STATE OF MAINE
DEPARTMENT OF TRANSPORTATION
16 STATE HOUSE STATION
AUGUSTA, MAINE 04333-0016

November 18, 2022
Subject: Bridge Rehabilitation
State WIN: 021751.01
Location: **Boothbay Harbor & Southport
Amendment No. 5**

SHEET NUMBER
13
OF 48

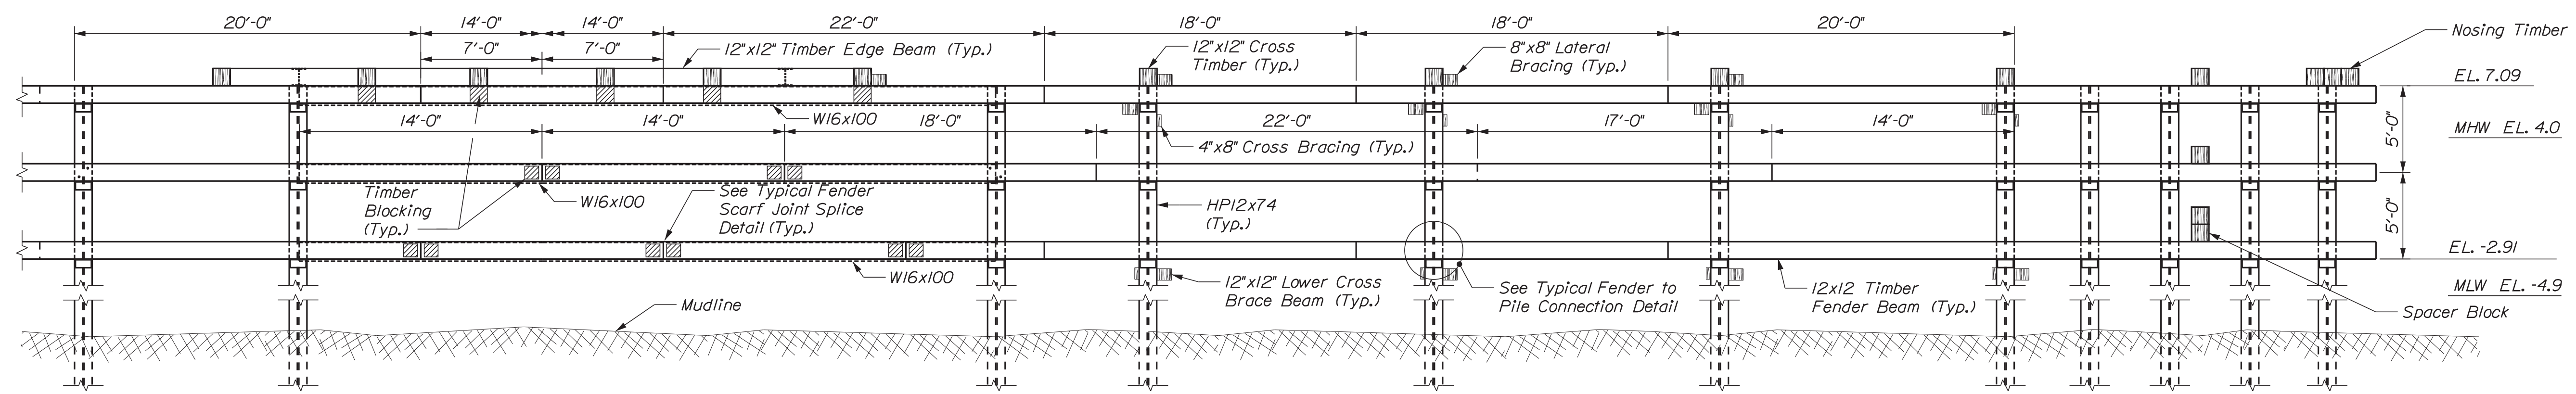
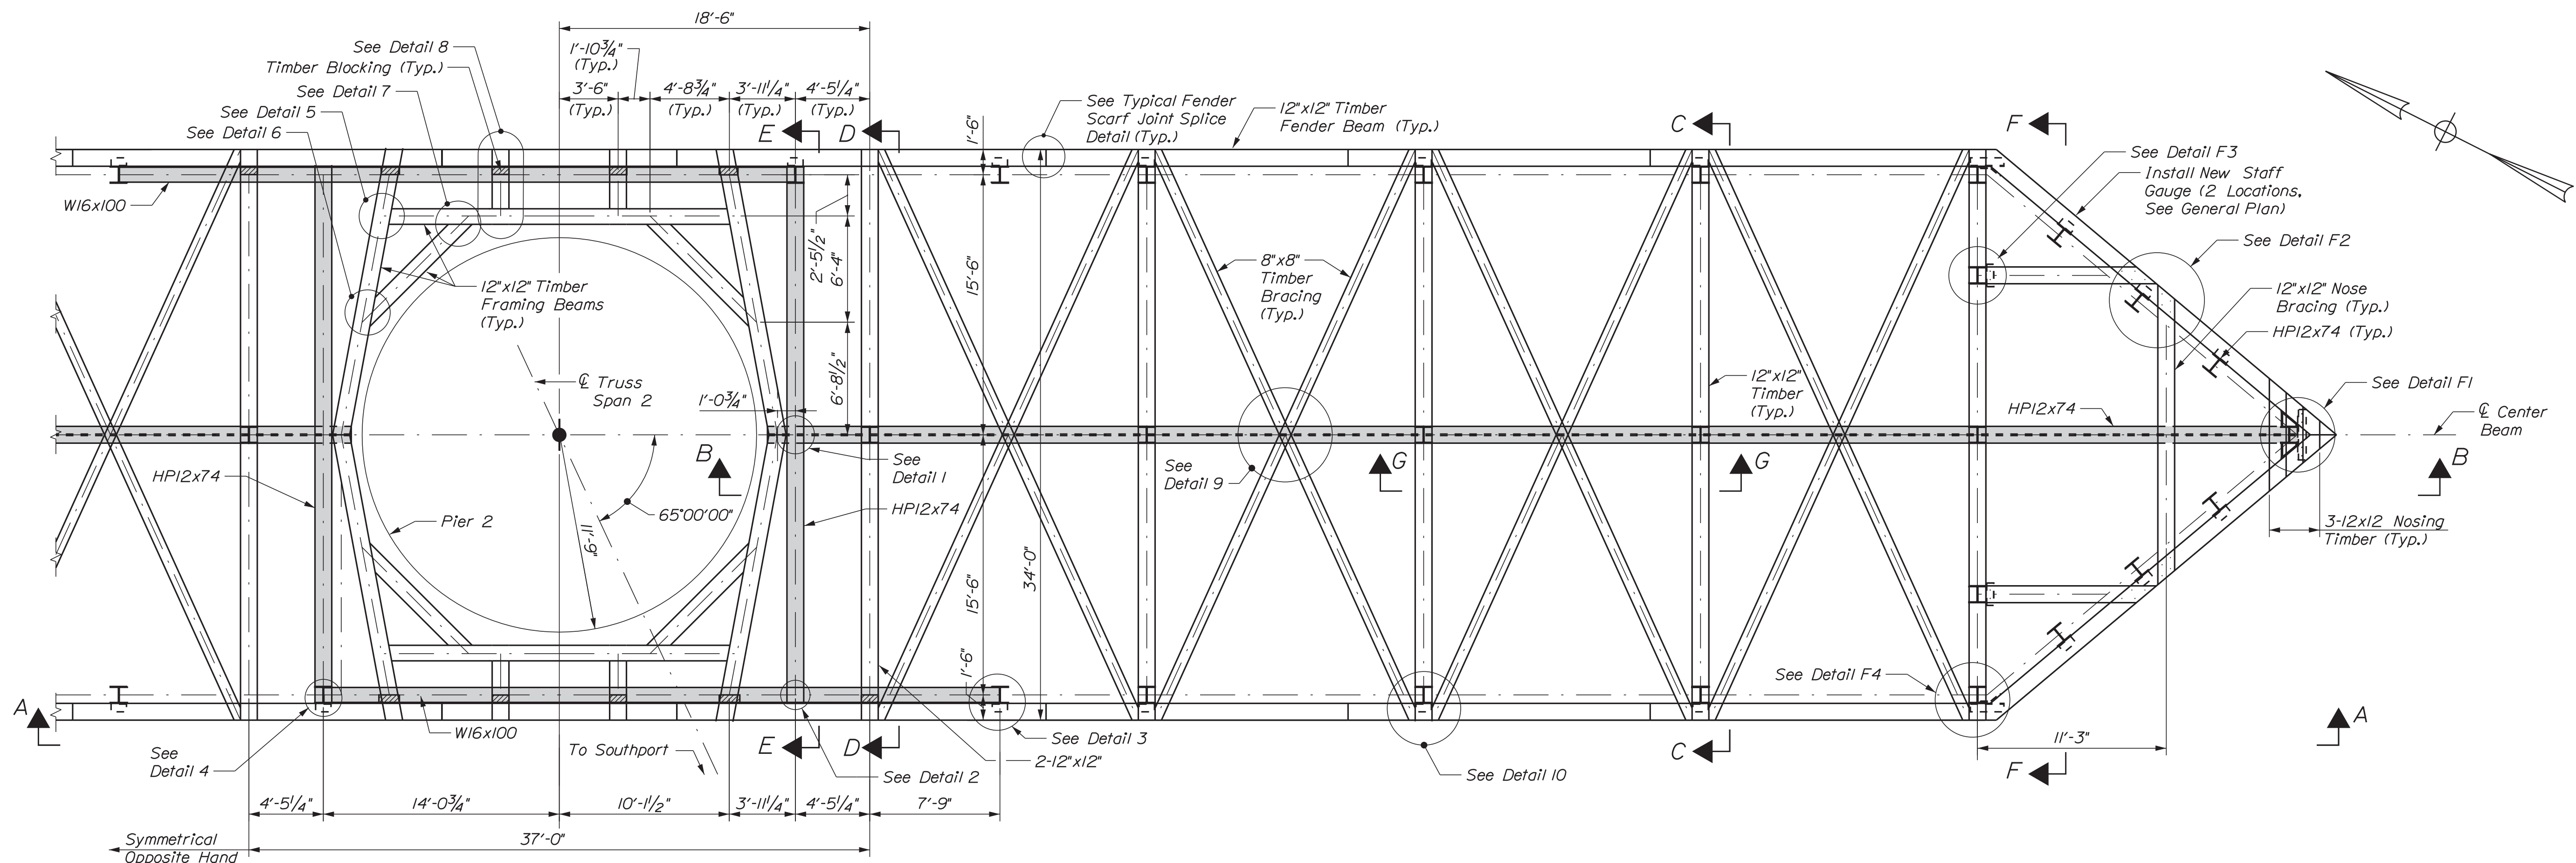
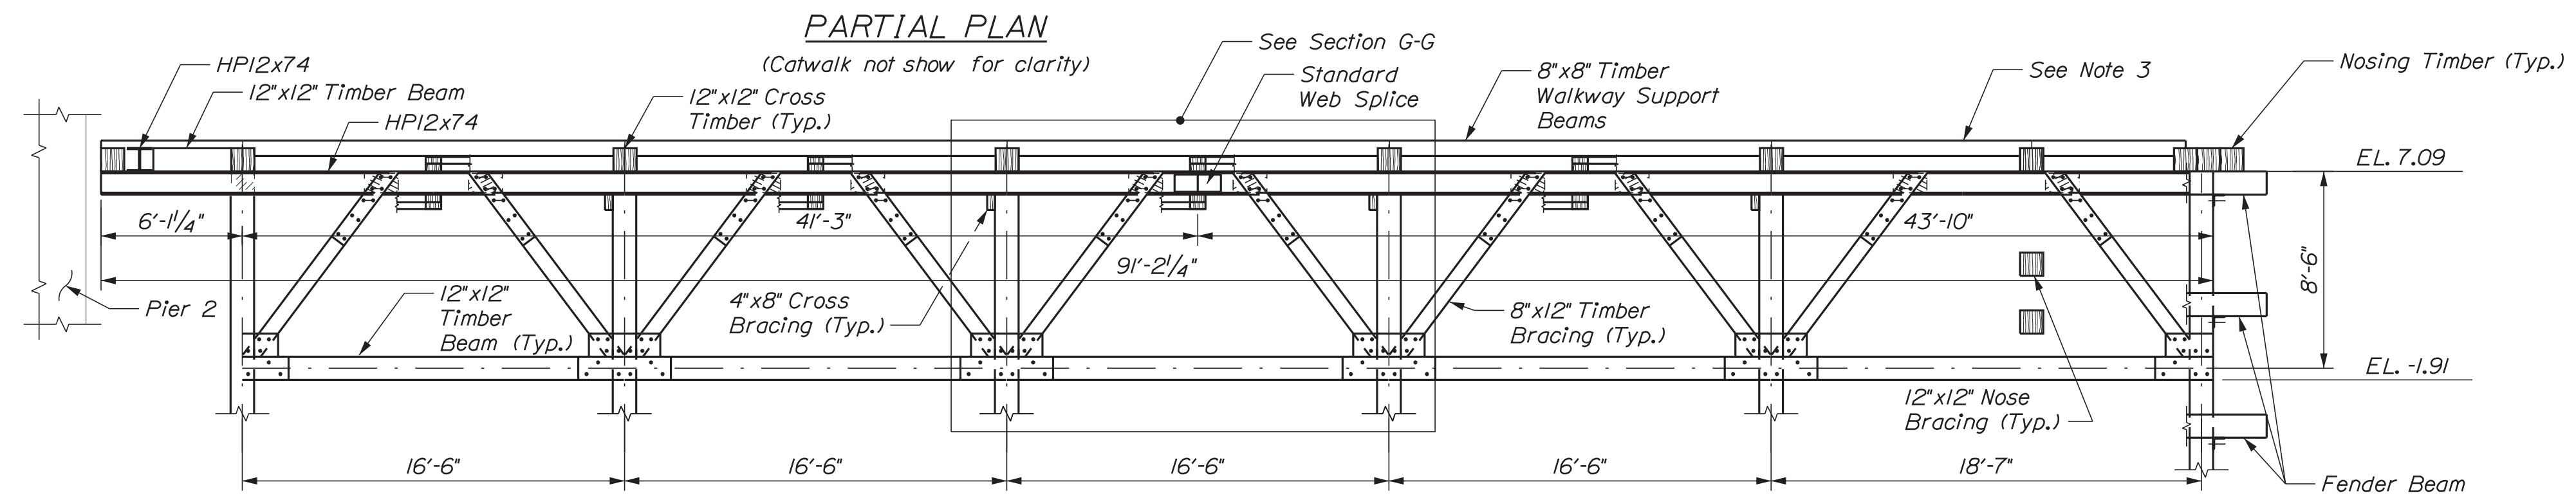
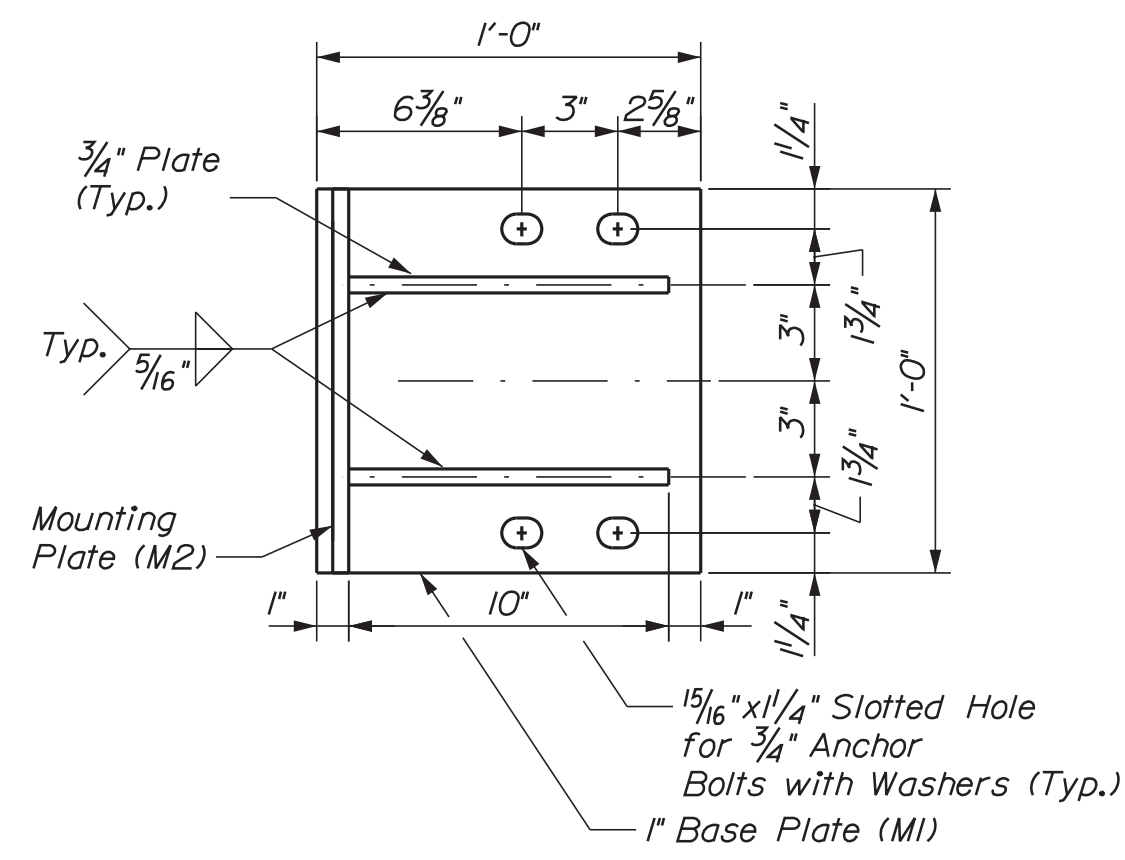
Question: Coast Guard General Construction Requirements note 14 supplied in bid amendment 1 states that "Bridge protective fenders shall not be constructed or rebuilt with any metal surfaces on the rubbing face of the fender system. All bolts, spikes or other metal fastening device must be countersunk." Does this apply to then plan specified carriage bolts on the "rubbing face" of the fender system?

Response: Please see revised plan sheet number 13 of 48. All bolt heads shall be countersunk on the fender rubbing face.
